DEPARTMENT OF TRANSPORTATION
STATE OF GEORGIA

FILE P.I. #0006327
CSSTP-0006-00(327)
GDOT District 1 - Gainesville
Barrow County
West Winder Bypass

SUBJECT **APPROVED REVISED CONCEPT REPORT**

REVISED PROJECT CONCEPT REPORT

TYPICAL SECTION

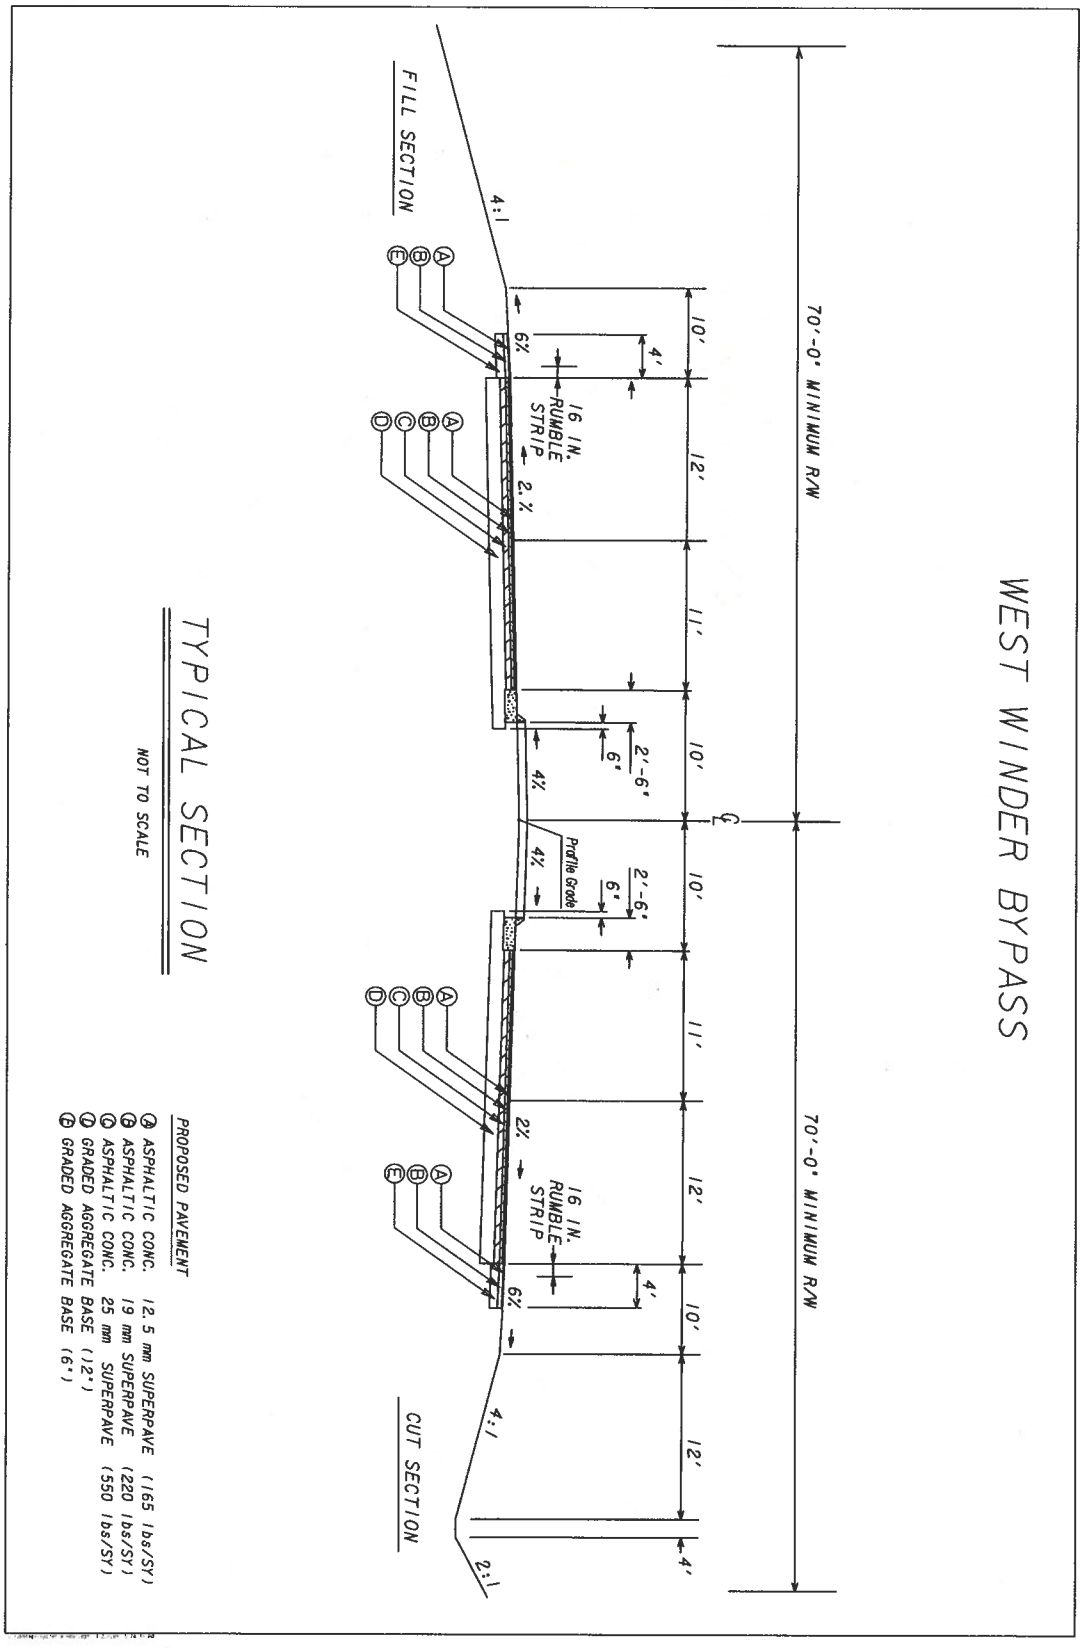
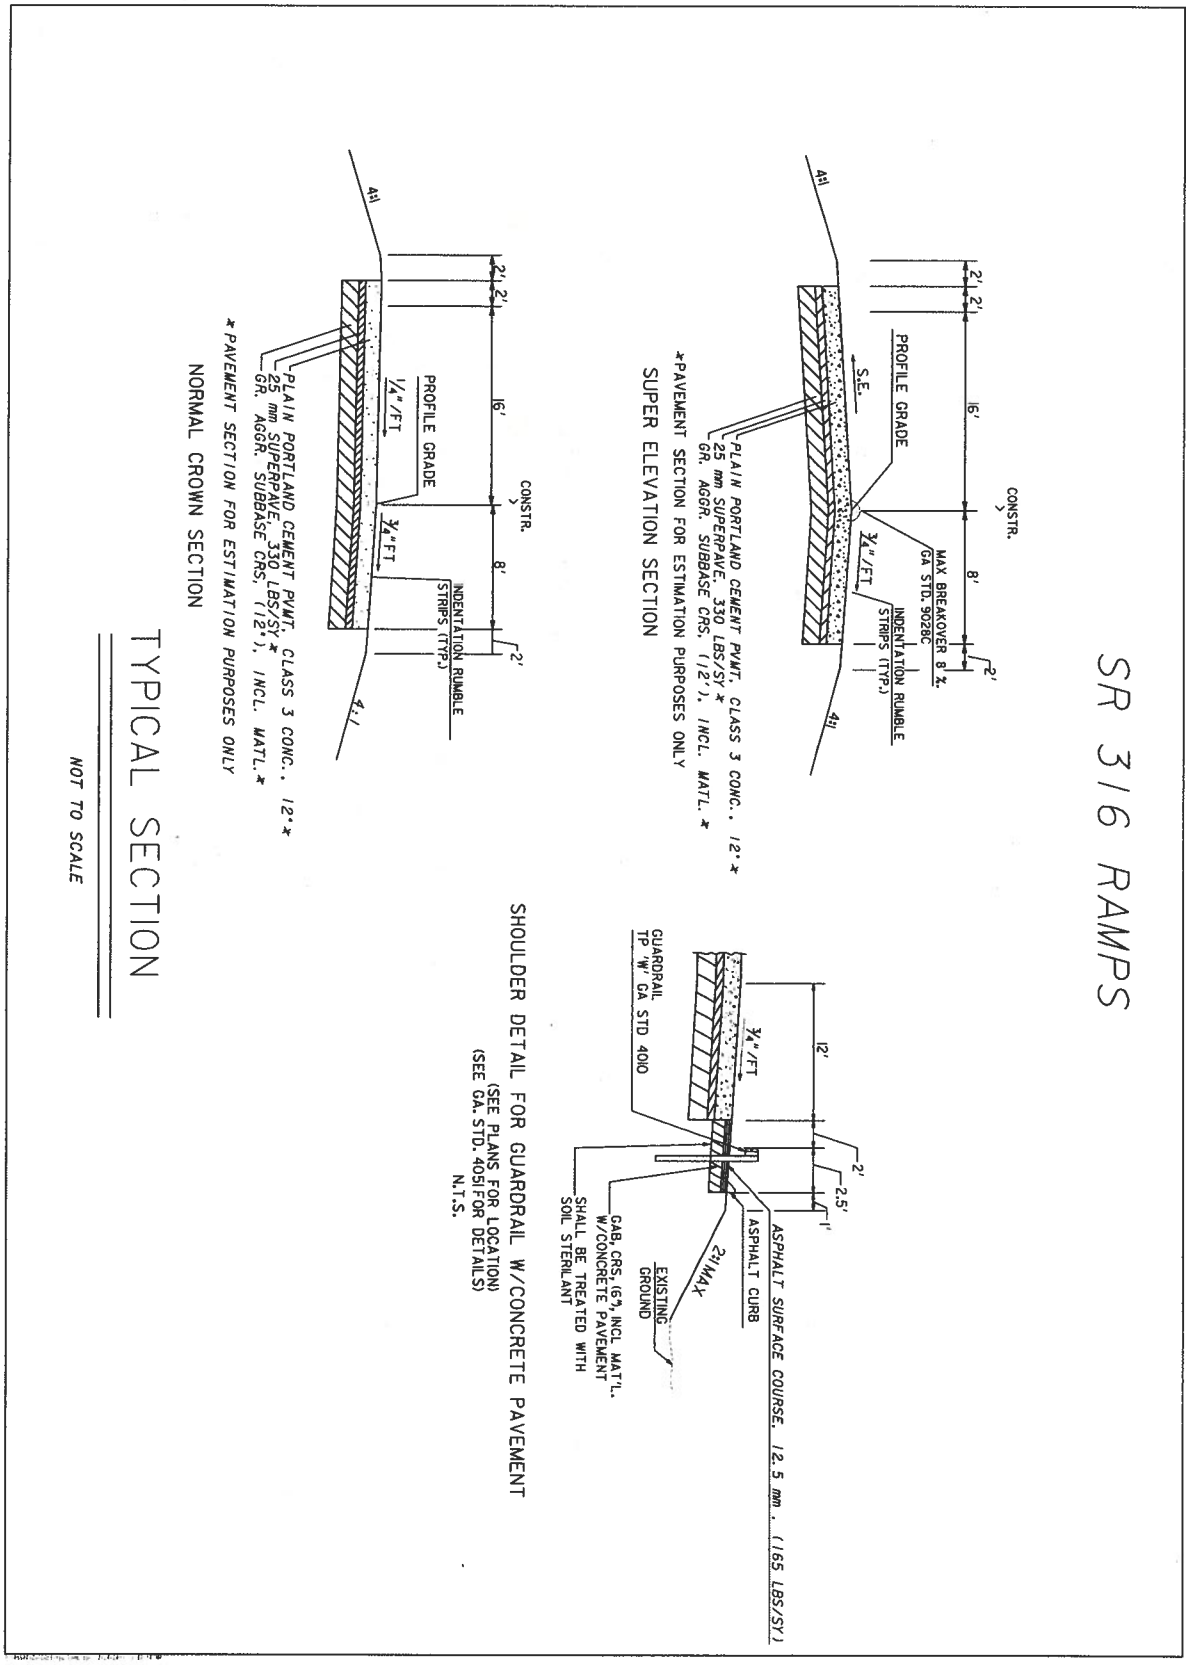
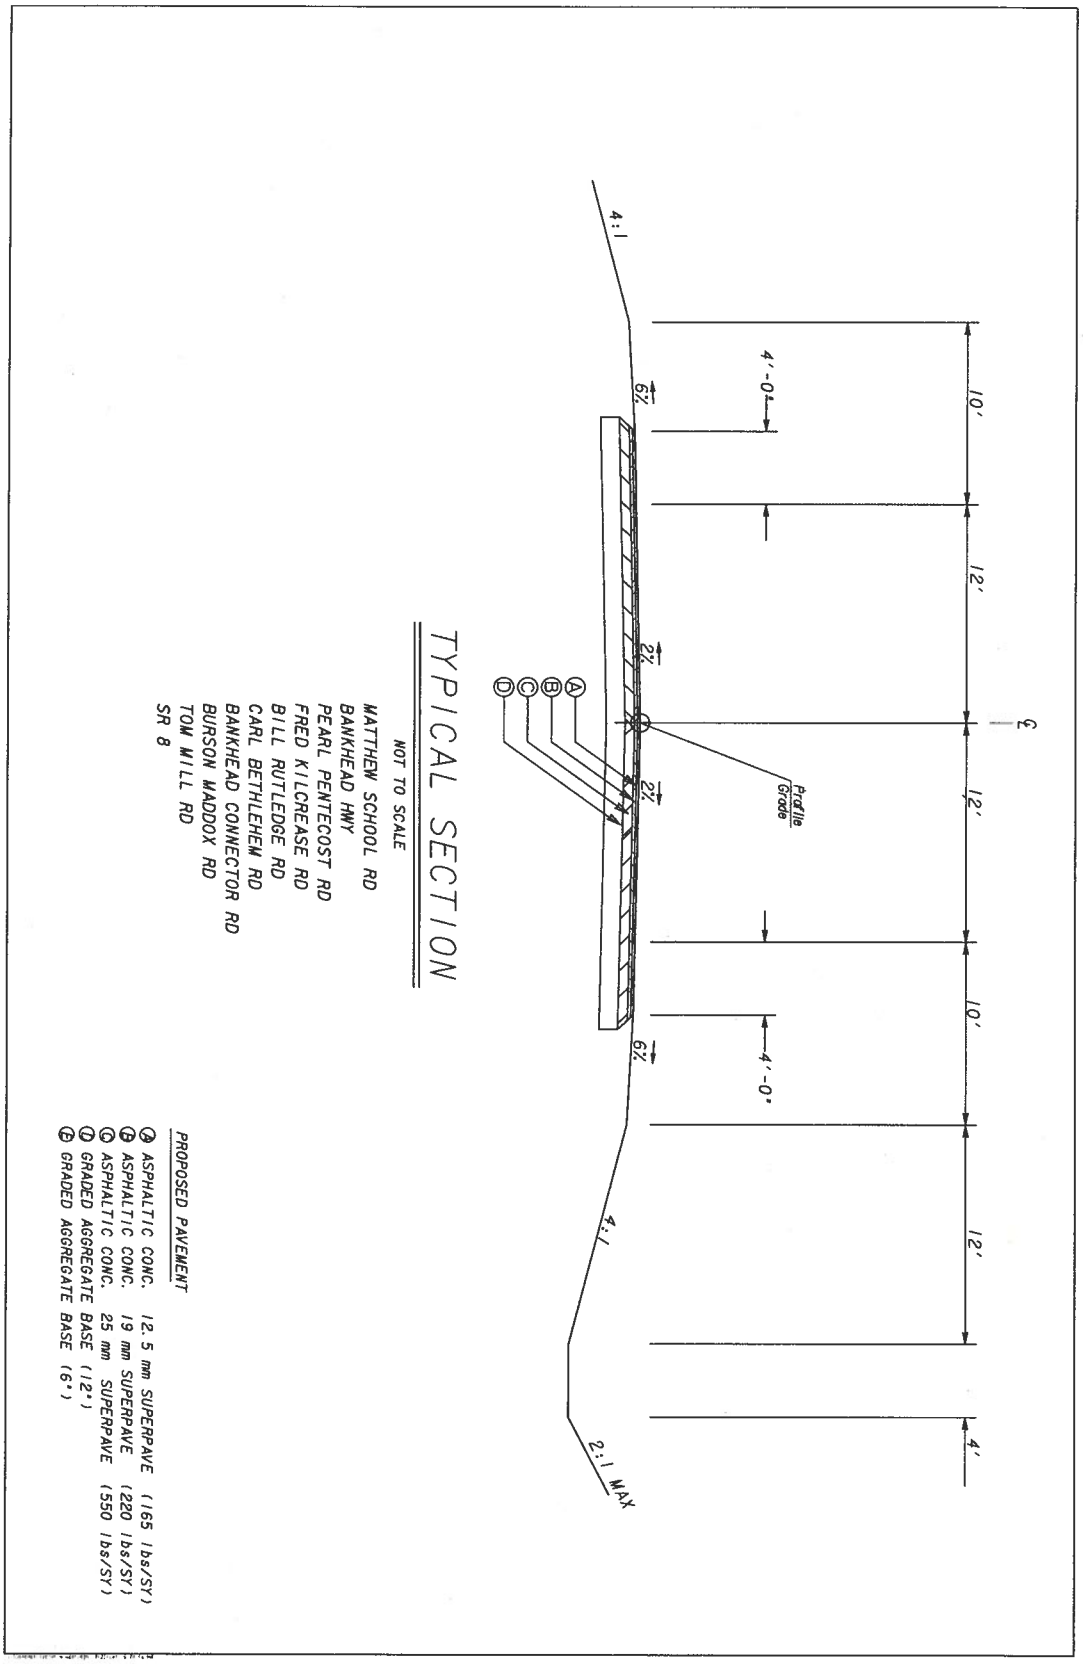
The features from the approved concept report are being revised by breaking the project up into three separate projects. Also, recommendations from the VE Study will revise the inside lane width, ramp shoulder widths, mainline shoulder widths, bridge shoulder width, and the median type.

- Reduce concrete paved shoulder widths on the ramps to and from SR 316 and the new West Winder Bypass. (Phase 3)
- Reduce the 24 foot median width to a 20 foot median width. (All Phases)

- Reduce the outside paved shoulder width from 6.5 feet to 4 feet wide. (All Phases)
- The VE study recommends a 10 foot bridge shoulder width. However, 8 foot shoulders will be utilized due to a change in standards in the Bridge & Structural Design Policy Manual. (Phase 1 & 3)

Potential Environmental Impacts of Proposed Revision: Environmental impacts are reduced by narrowing the typical section. The roadway median type of the typical section was revised from a 24' to a 20'raised concrete median, the inside lane and shoulder widths are also reduced. Another opportunity for public involvement will be available at the PIOH scheduled in the fall of 2011.

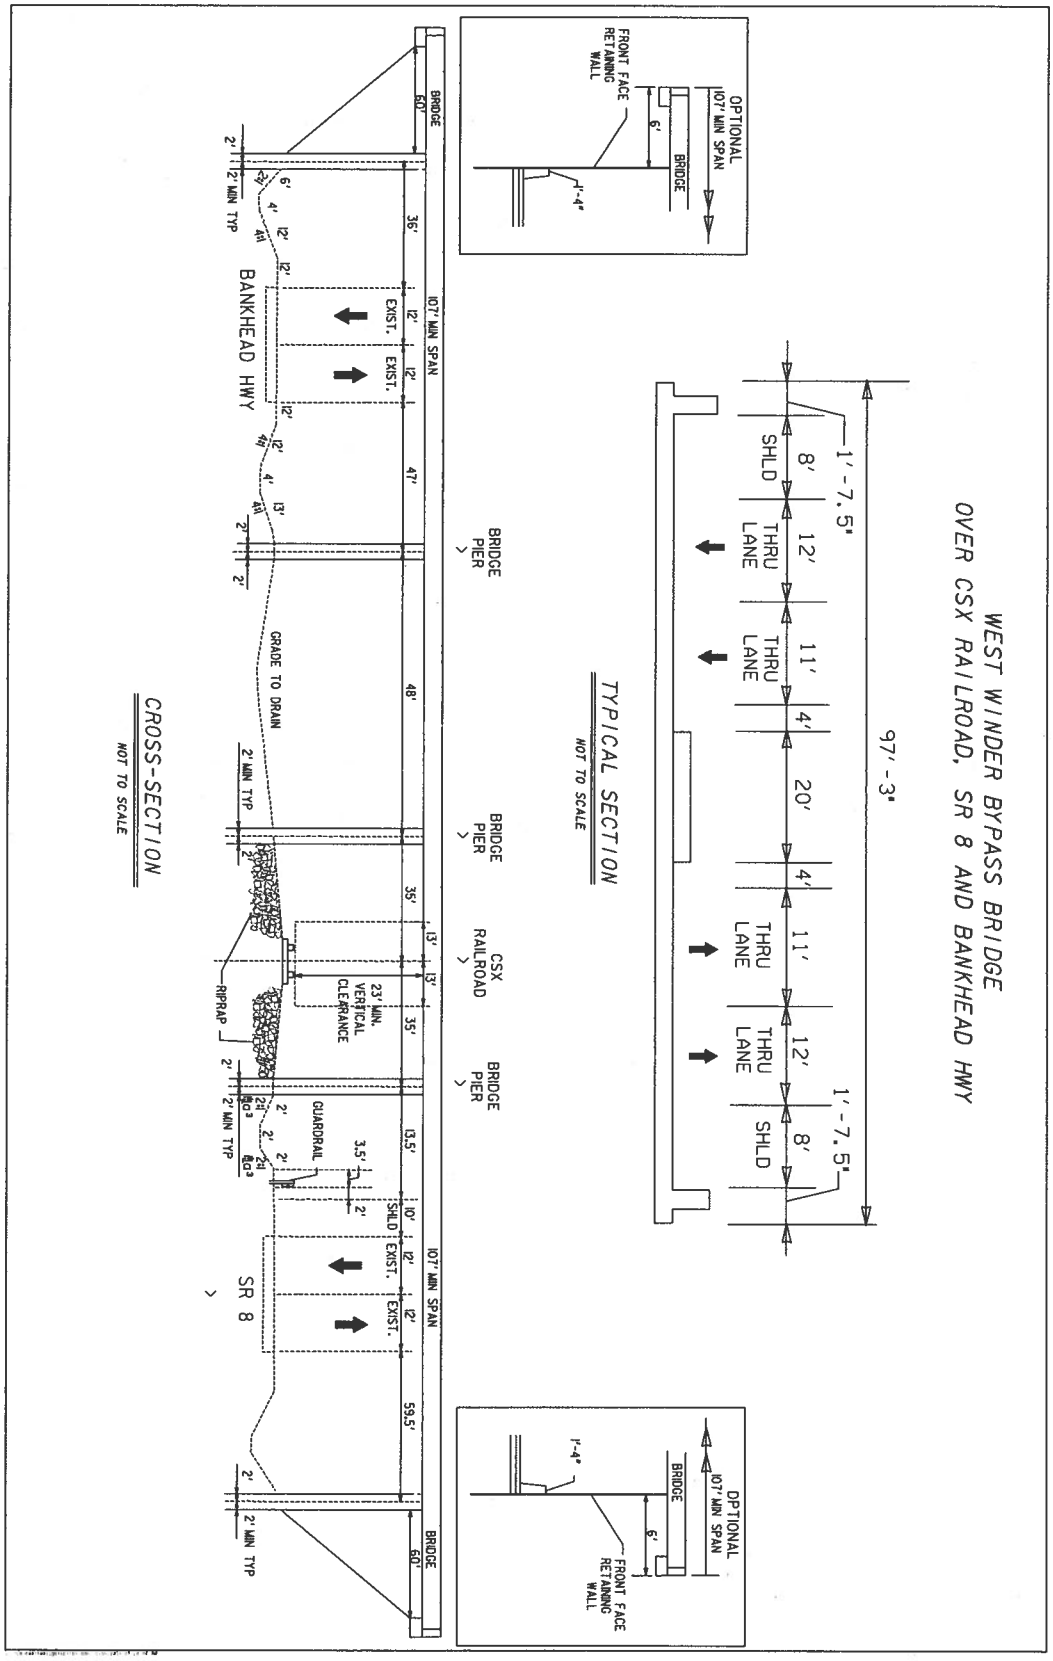
15) **Alt. No. 25: Delete the center pier for the West Winder Bypass bridge over Bankhead Highway, CSX Railroad and SR 8.**
VE Team Savings = $160,000

Recommendation: **Implement with Modifications**. In accordance with Policy 4265-9 (Geometric Design Guide for Bridges on Local Roads and Streets, Not Having State Route Numbers) the outside bridge shoulder width should be a minimum of 8 feet. The designer needs to determine if a wider shoulder is warranted for this project based on volume of truck traffic.
